Service Bulletin No. 390B

| MODEL E4500 / J4500 Series Coaches | TYPE Field Change Program | SECTION/GROUP 3-Body | DATE Sept. 21, 2012 |
| SUBJECT DRAIN HOLES IN DRIVE AXLE SUSPENSION SUPPORT STRUCTURE | | | |

Figure 1. Drive axle support structure cross tubes.

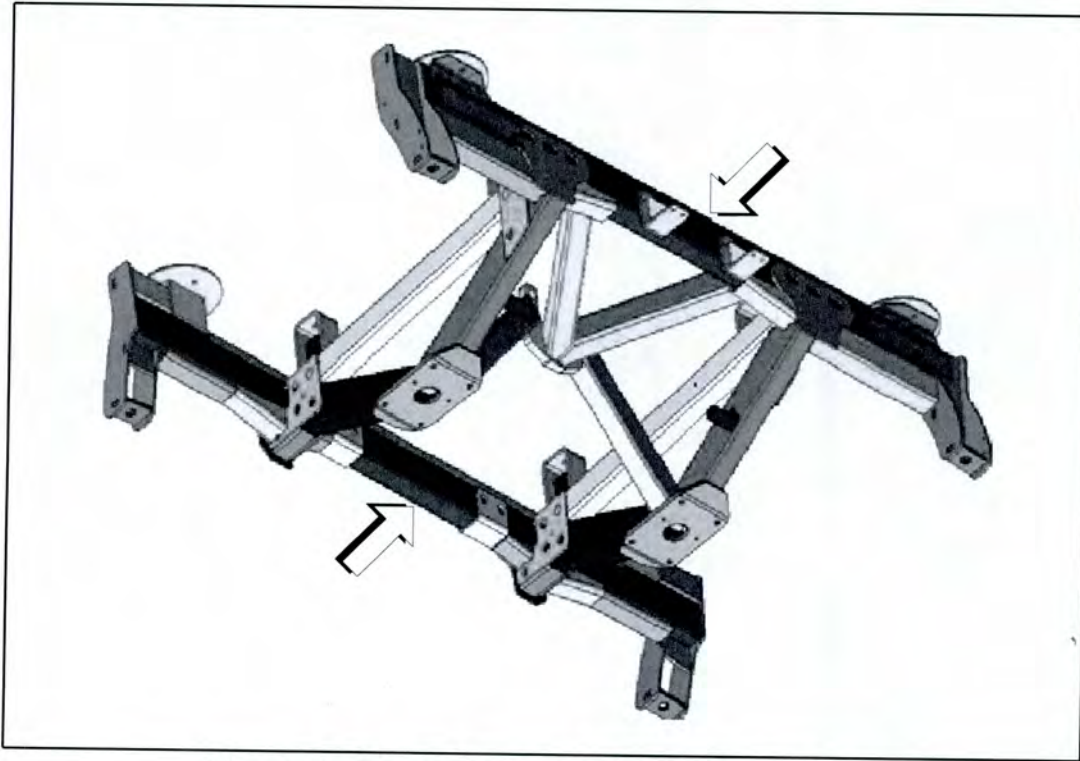
4. Using a caliper, measure a clean area of the outside front–rear dimension on each of the two (2) drive axle support structure cross tubes.

In the event that either of the front–rear measurements exceeds 3.18 inches, without the presence of rust, dirt or debris, or if a crack is present anywhere on either cross tube, contact the MCI Fleet Support Technical Center at 1-800-241-2947 for further information, before proceeding any further.

Figure 3. Front of drive suspension support structure.

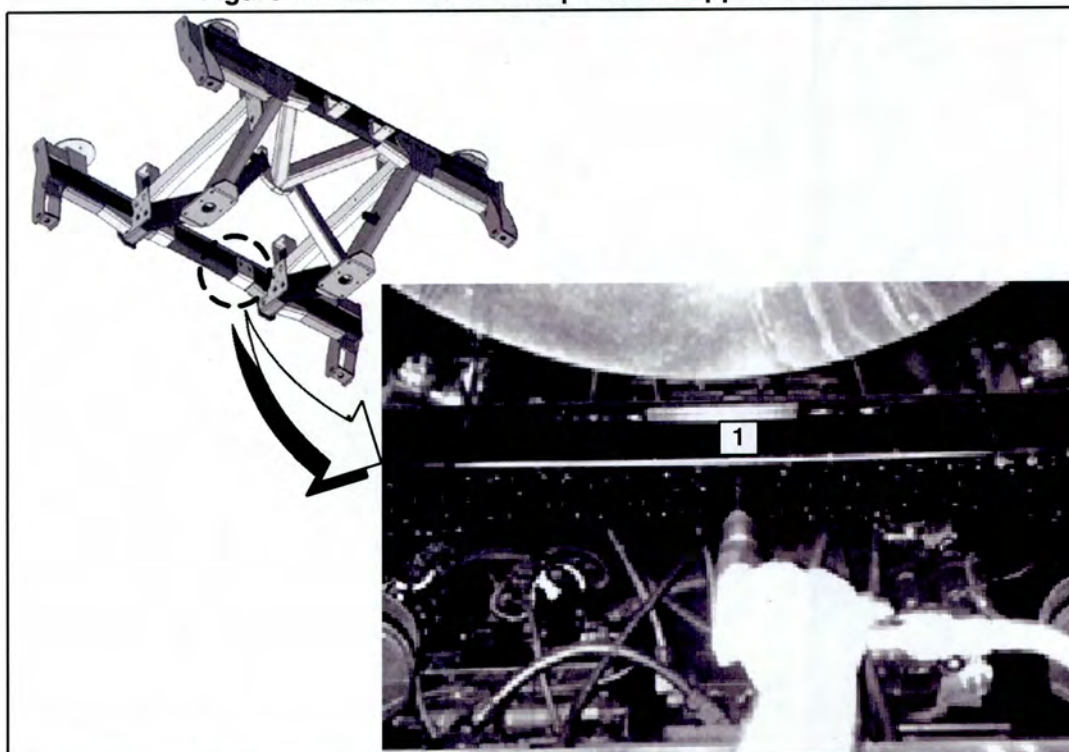
5. With the coach on a lift or over a pit, use a 0.250 inch drill bit to drill a hole in the bottom face of each of the cross tubes as shown in Figures 2 and 3.

| ITEM | DESCRIPTION |
|-------------|--|
| 1 | Drill a 0.250 inch hole in the bottom face of the cross-tubes. |

Figure 4. Drain hole drilled in the drive suspension support structure (roadside of coach shown).

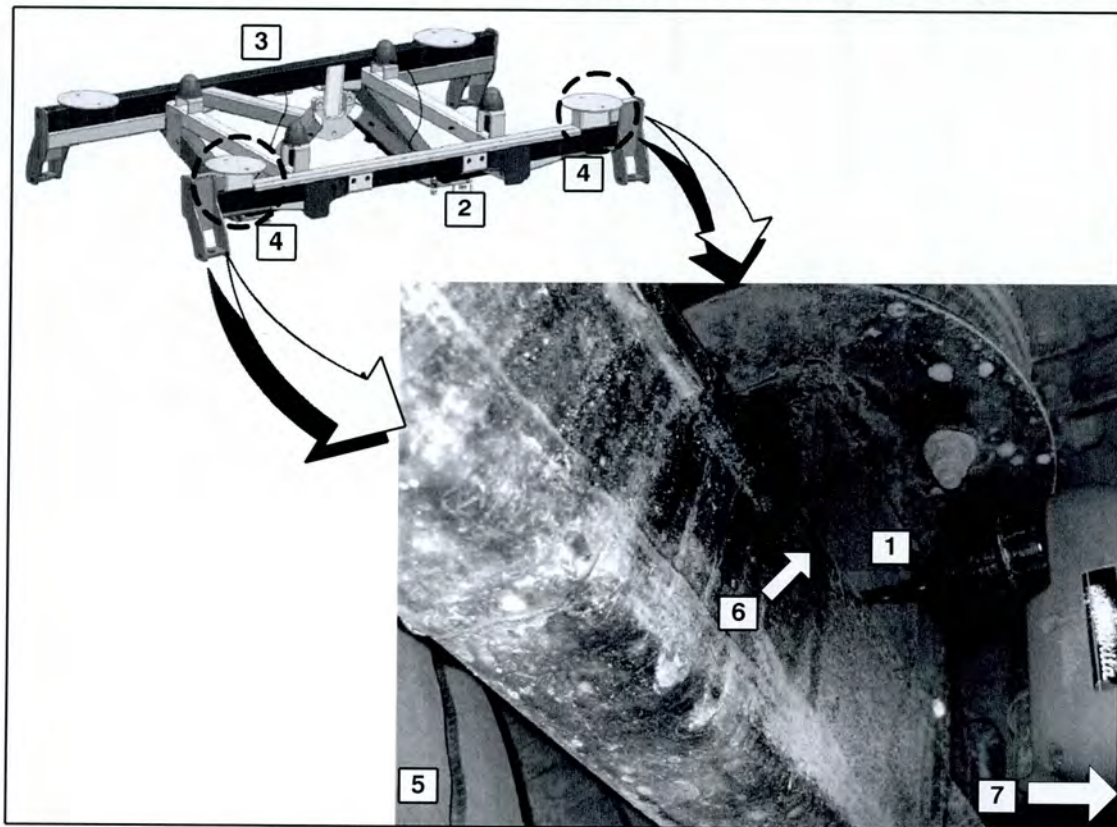
The holes that are to drilled in Step 6. (Figures 4 and 5) must be drilled on the front vertical face of the tube to prevent the potential for water spray intrusion from the drive axle wheel.

6. With the coach in the High Ride position, use a 0.250 inch drill bit and an angle drill to drill a hole 0.125 inch above the weld, directly underneath the air bag on the front, vertical face of the tube (on the opposite side of the drive axle wheel) as shown in Figure 4. Repeat to other side of the tube (refer to Figure 5).

| ITEM | DESCRIPTION |
|-------------|--|
| 1 | Drill a 0.250 inch hole 0.125 inch above the weld (in the area shown), directly underneath the air bag on the vertical face of the tube. |
